**ATS WORKING GROUP
COMMENTS ON 2009 DRAFT CONSTRUCTION GENERAL PERMIT
JUNE 23, 2009**

COMMENT 1.

Active Treatment System (ATS) Requirements

RELATIONAL TRENDS OF FRESH WATER FISH ACTIVITY TO TURBIDITY VALUES AND TIME

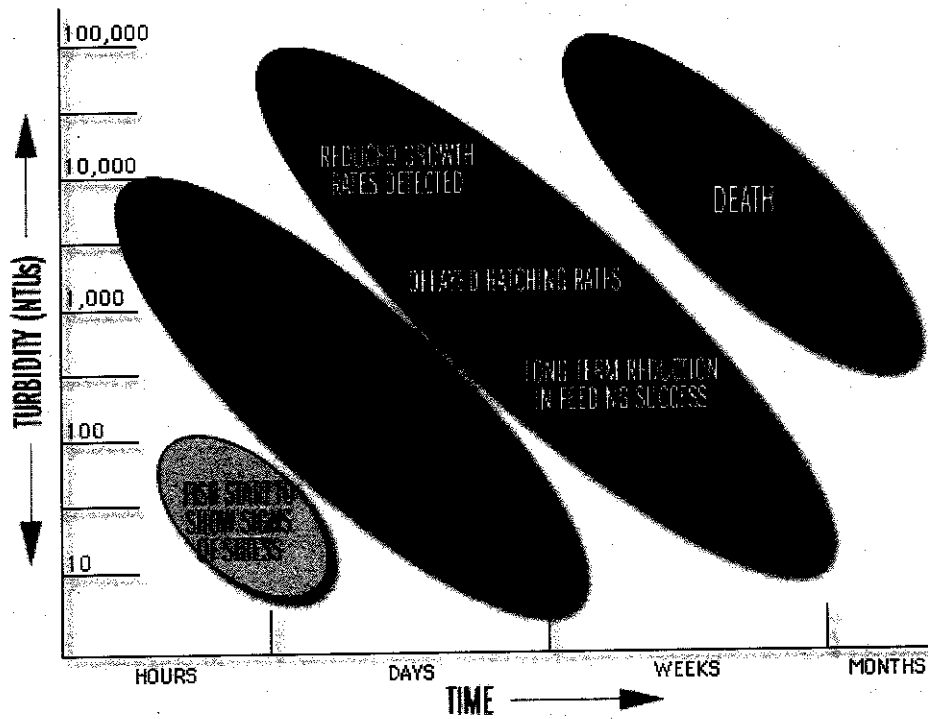
Numeric Action Limits (NALs) at 250 NTU and Numeric Effluent Limits (NELs) at 500 NTU are not providing clean enough water to protect these aquatic species and prevent destruction of their habitats. Technology is available that can provide the desired water quality and the concern of cleaning the construction stormwater run-off "too much" is a fallacy. ATS could be designed to "side stream" some unfiltered water and blend that with treated water to give the ideal amount of "natural" sediment. However, ATS Workgroup doesn't see that as being a problem, in all our combined years of experience, we have not seen "too clean" of water causing stream erosion because of a "lack of sediment".

The following chart shows a simple summary of the relationship between turbidity and time. Please take note of where 250 and 500 NTUs fall on the graph and given a day at those levels can cause aquatic species to act in ways that directly or indirectly may lead to reduced pollution over time.
